NEW MURRAY MIDDLE SCHOOL

SUMMARY OF RESISTANCE TO BLAST LOADS

BUILDING TYPES A, C, AND D

PHASE 1

Figure 1: Bolt and Stiffener Plate Locations for 12x40 Modules

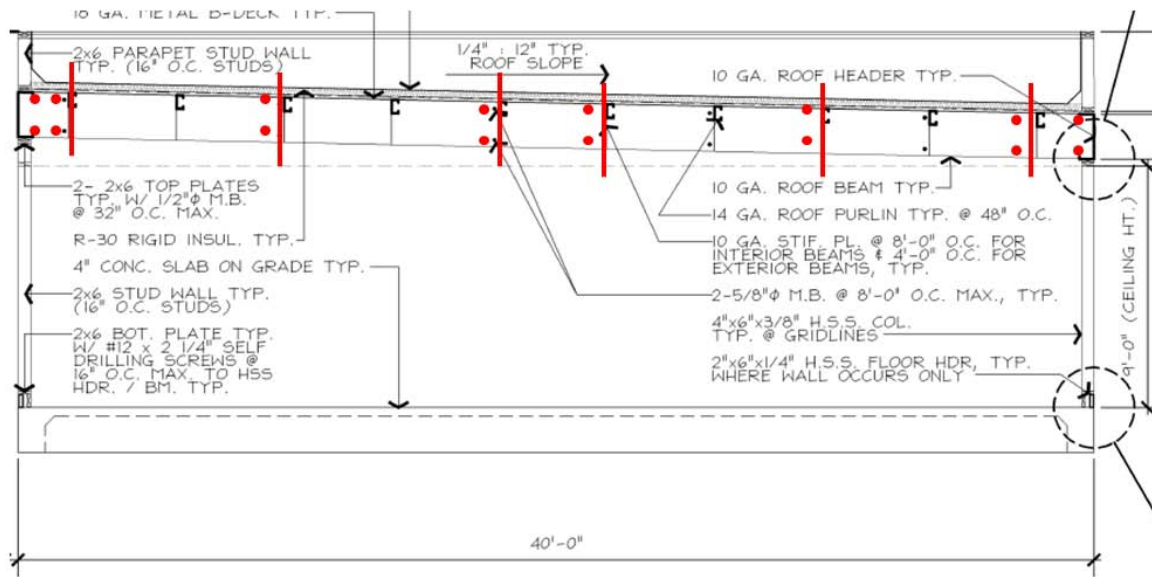
- 1) Interior roof beams should conform to the bolt and stiffener plate layouts shown in Section 5.
- 2) 5/8" metal bolts @ 32" o.c. and top plate nailing insufficient for in-plane shear and uplift from roof rebound (uplift) due to blast. Because the response of the top plates and header beam (or exterior beam) is dependent on the nature of the upgraded connection scheme, Phase 2 work will be required to provide an accurate analysis of these sections. For estimating purposes, it should be expected that the header beams will require welded 10 gage stiffener plates at 4'-0" o.c. at a minimum.

The images below are provided to show the desired bolt and stiffener plate spacing for interior roof beams. Sizes and spacings are not to scale and only intended for use as rough schematic outlines for locations. Typical edge distances and sizes should be used. The layouts shown maintain the maximum spacing of 8' as shown in the Baseline Drawings. Exterior roof beams should use typical spacing patterns with all welded stiffeners at 4' o.c. as noted in the Baseline Drawings. Figure 3 is typical for all 60' interior beam spans. The 1 1/2" stiffener welds at beam web should be spaced at no more than 5" o.c. Welds at beam flange should be the full length of the beam.
